Amendment to Unit 6:
Second floor removed. House changes from 4 bedroom to a 3 bedroom detached house.
Roof profile changed from pitched roof to flat roof.
Design of facade to match ground and first floor but also to mirror front facade of unit 7.
Building height reduced by 4.145m from 42.570m to 38.425m.
All first floor windows of north elevation to have manufactured obscured glass to prevent overlooking.

HOUSE TYPE B (UNITS No.3/4/5)
PROPOSED SIDE (SOUTH) ELEVATION
Scale 1:100

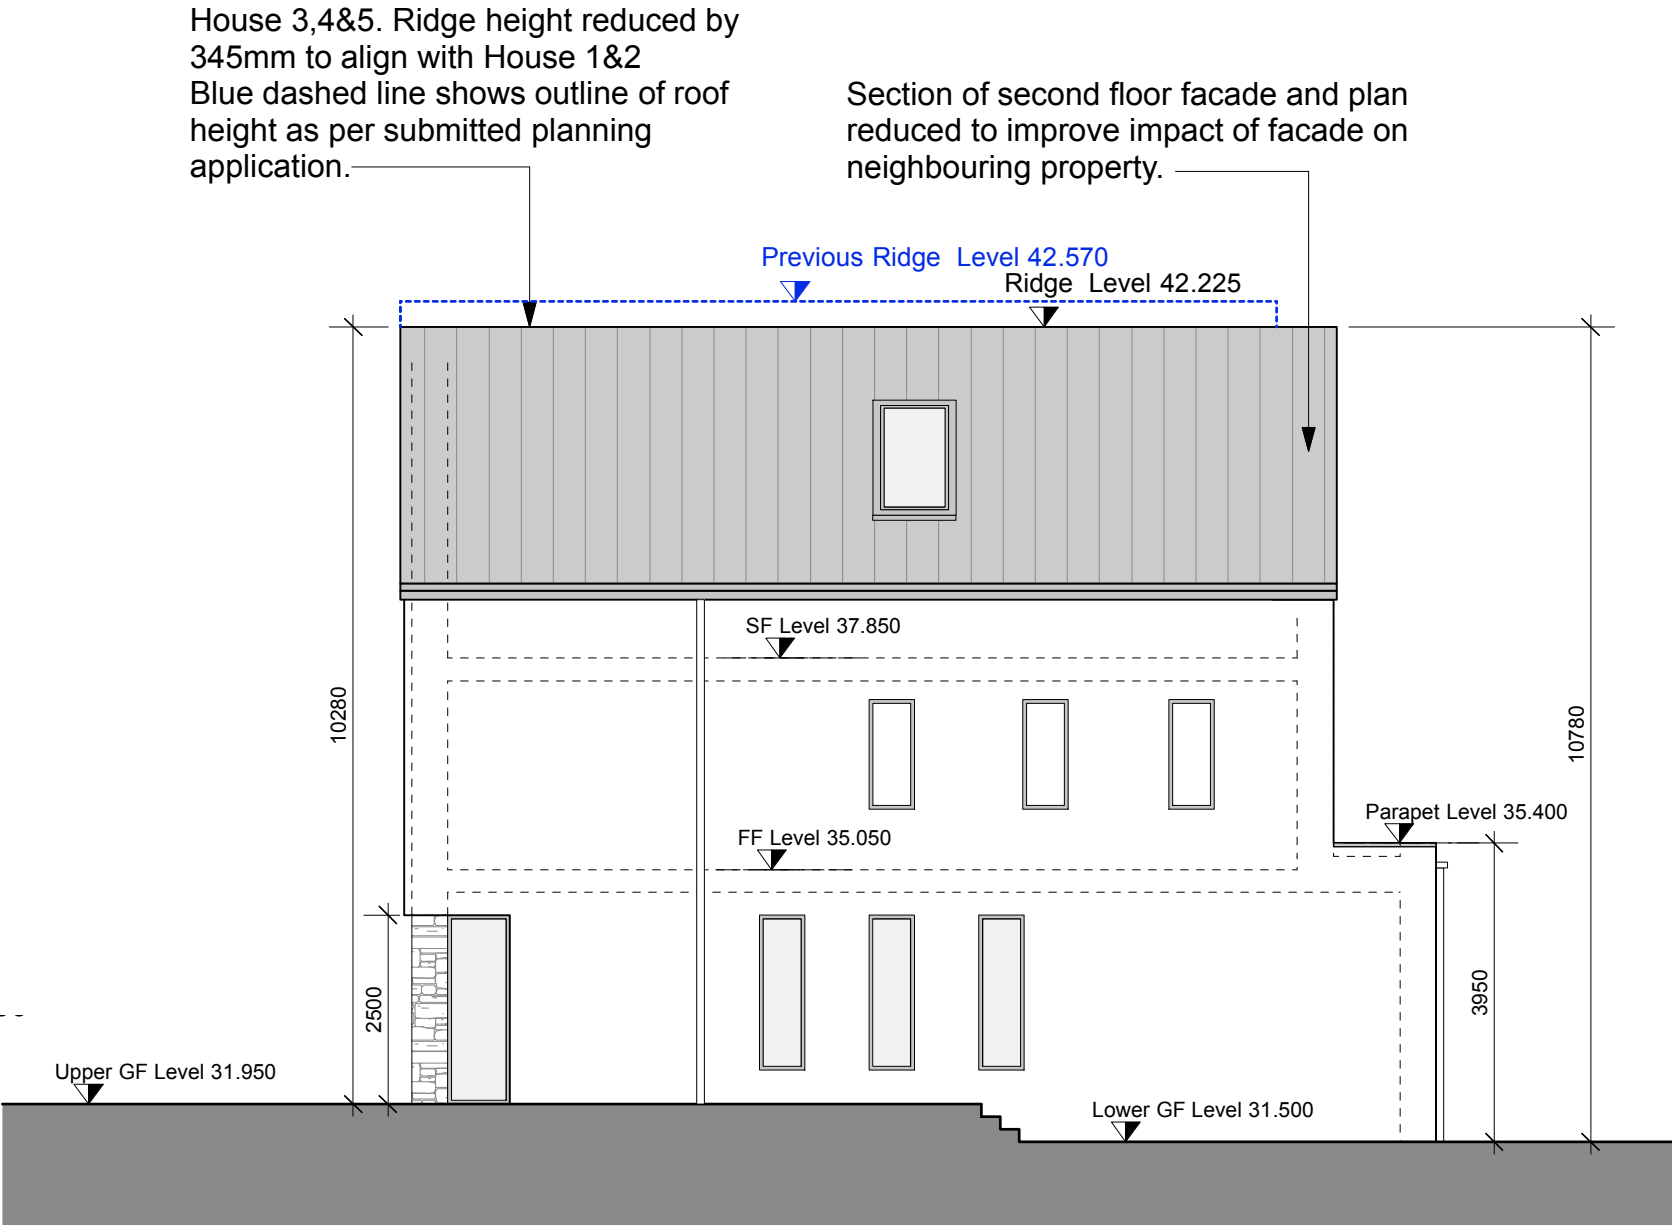
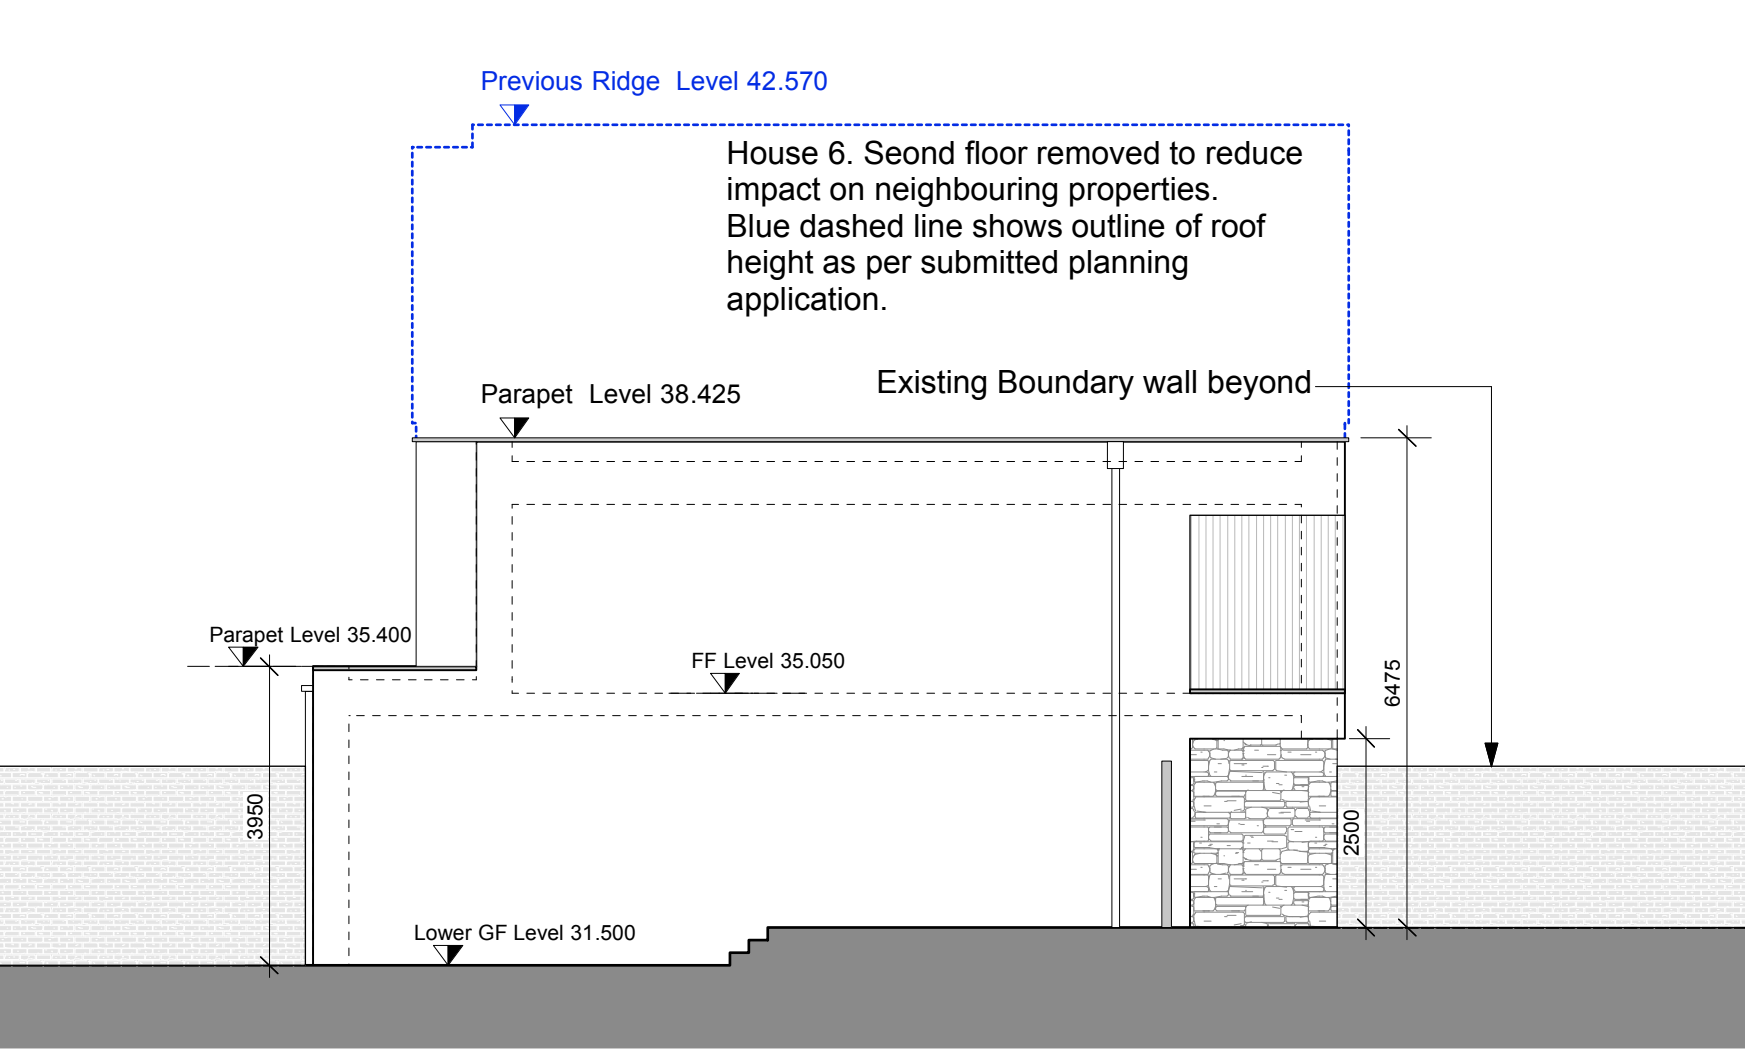
Amendment to Unit 3, 4 & 5:
Building height of 3 units reduced by 340mm from 42.570m to 42.225m to align with ridge height of unit 1 & 2.
Material change on second floor of west facade of 3 units to match roof finish.
Finish change will help reduce visual massing of the houses and reduce the visual impact on the neighbouring property.

HOUSE TYPE C (UNITS No.7 & No.8)
PROPOSED SIDE (SOUTH) ELEVATION
Scale 1:100

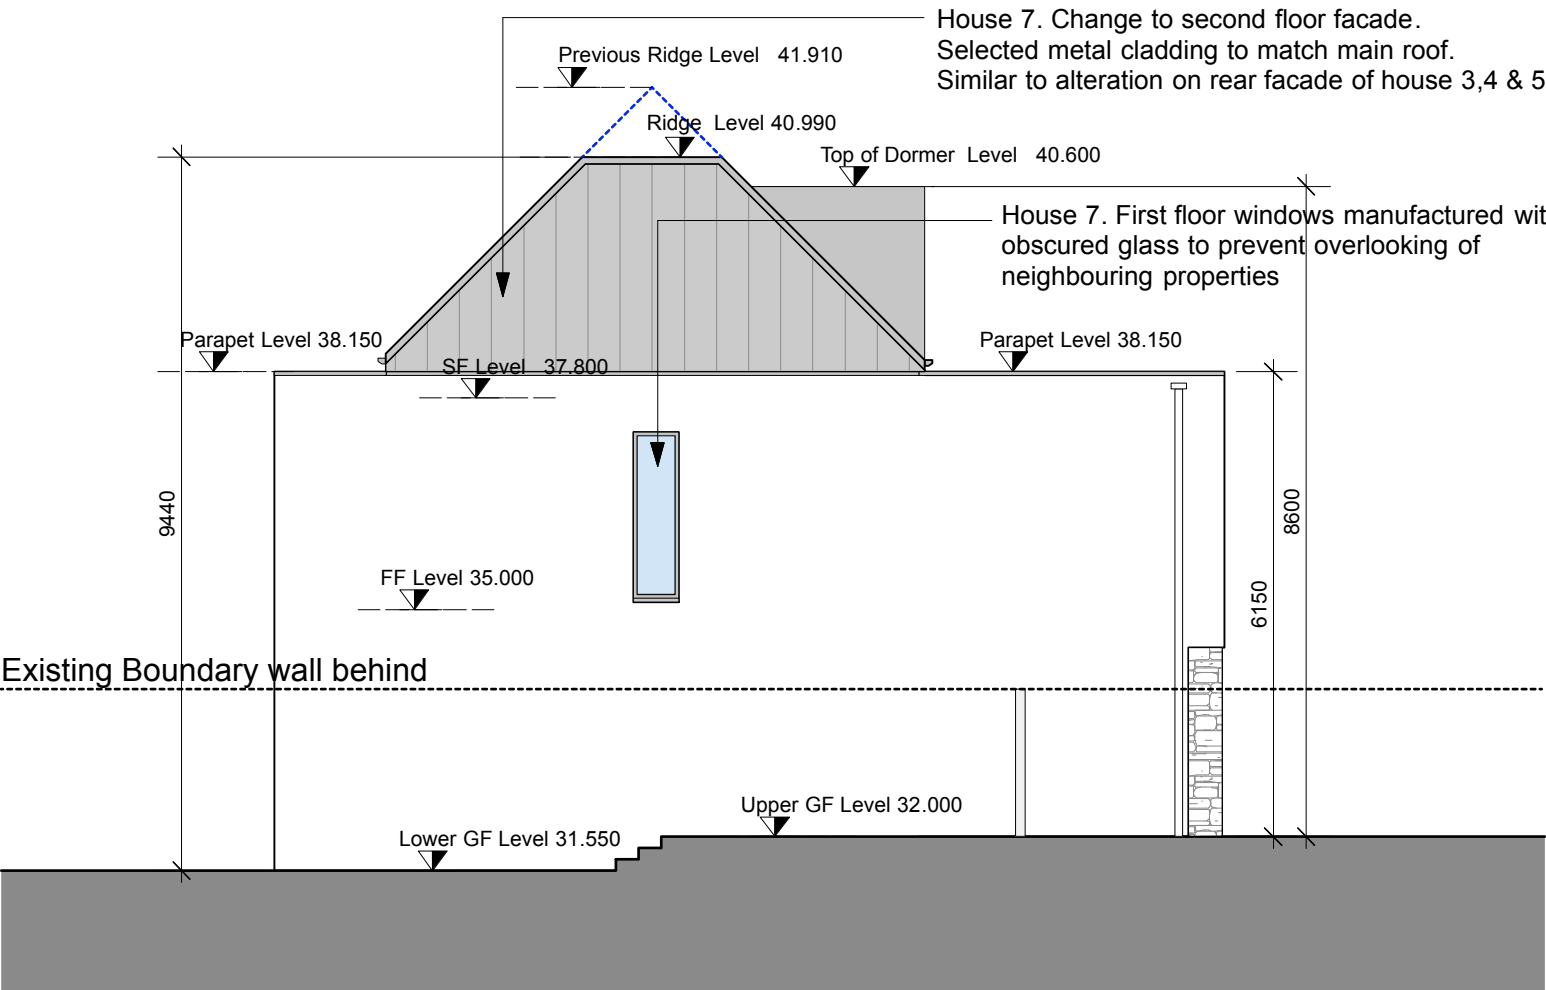
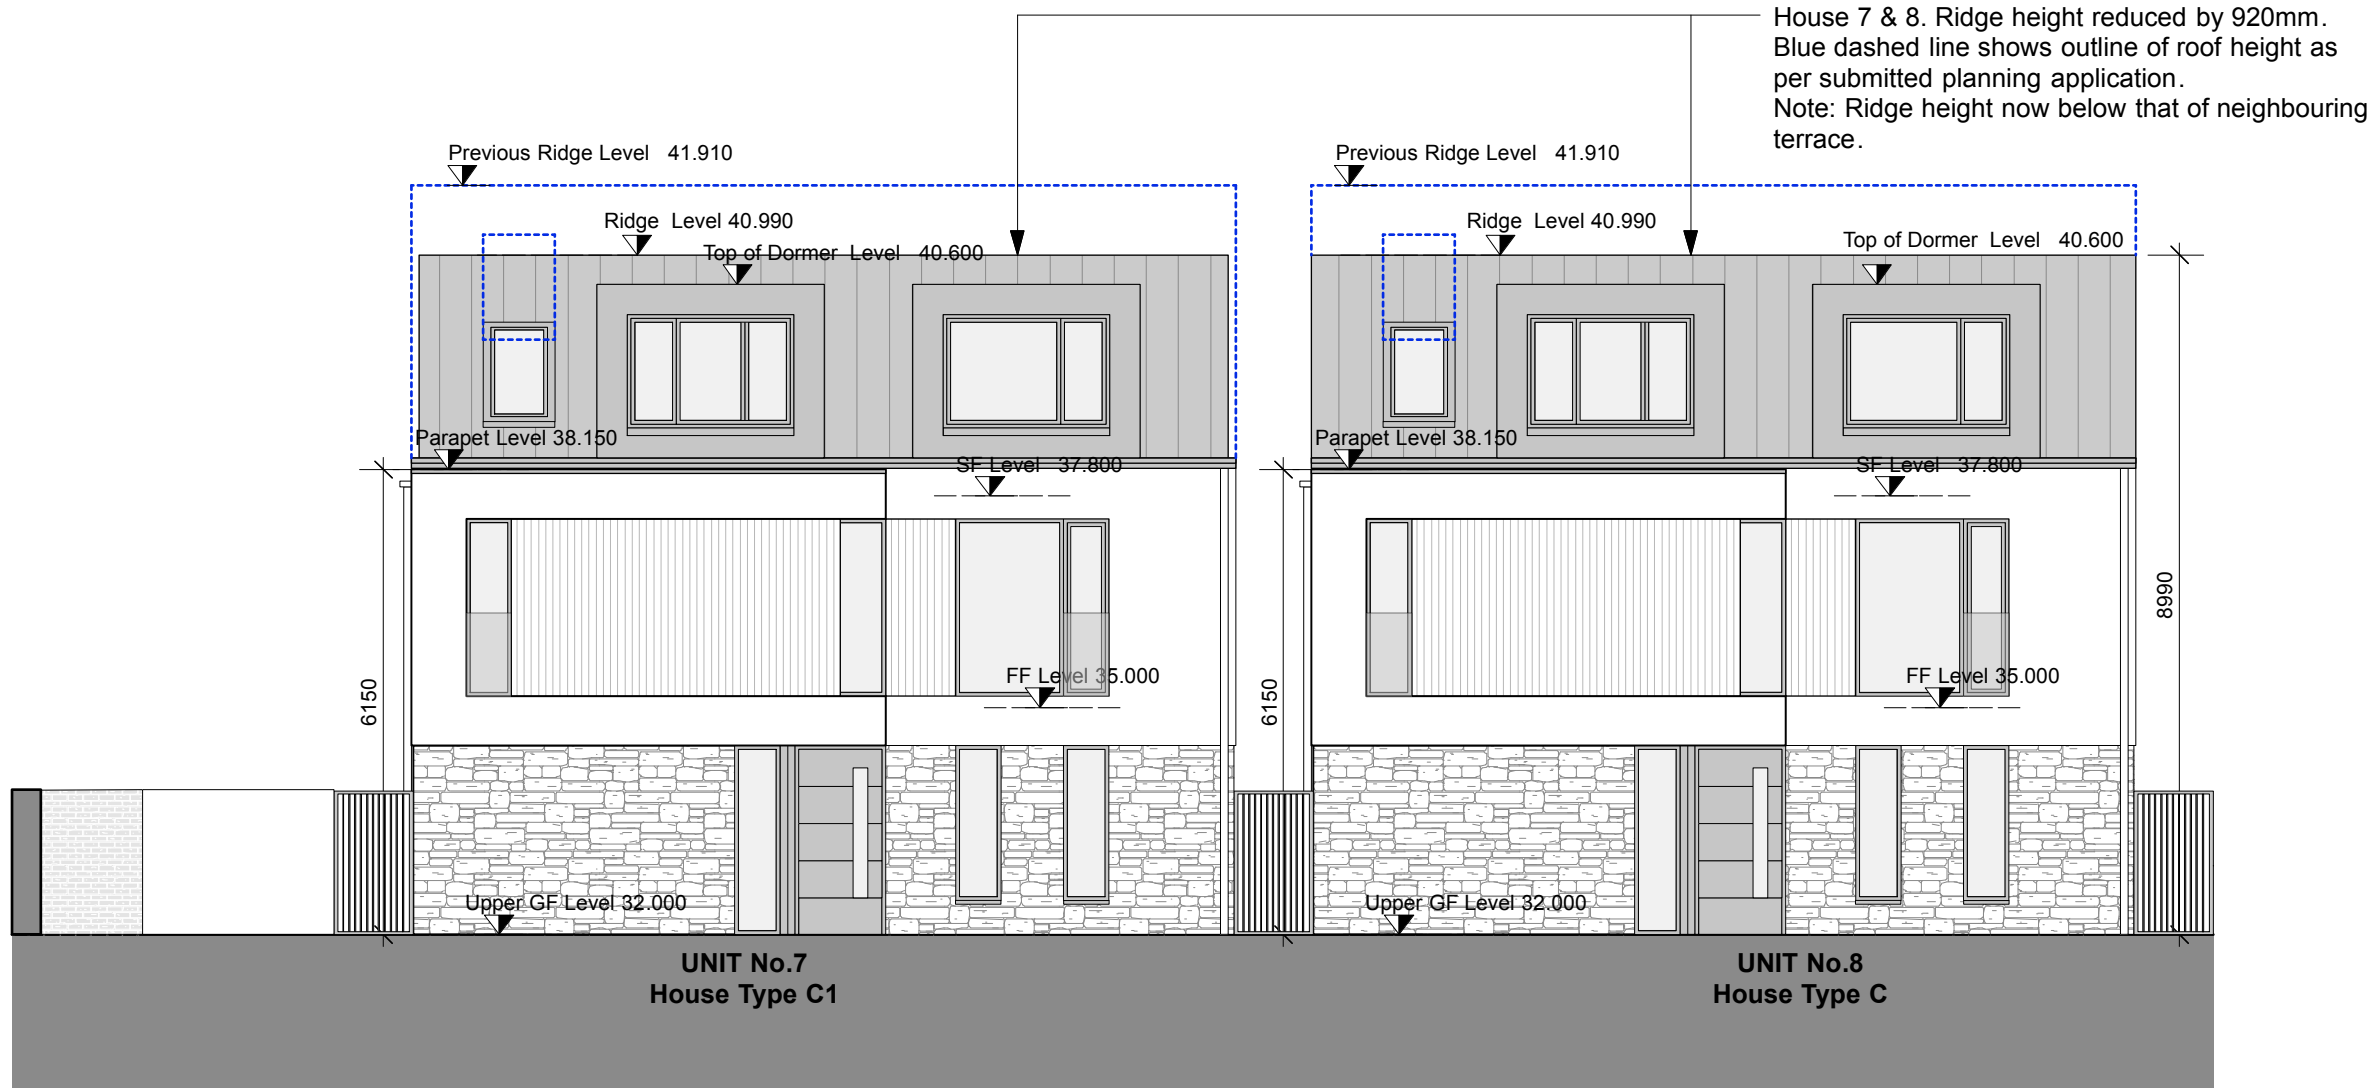
Amendment to Unit 7:
Roof profile changed and building height reduced by 920mm, from 41.910m to 40.990.
Material changed on second floor facade of north elevation to match roof finish.
Change of material to reduce the visual impact of the gable facade on neighbouring property.
All first floor windows of north elevation to have manufactured obscured glass to prevent overlooking.

Amendment to Unit 8:
Roof profile changed and building height reduced by 920mm, from 41.910m to 40.990.
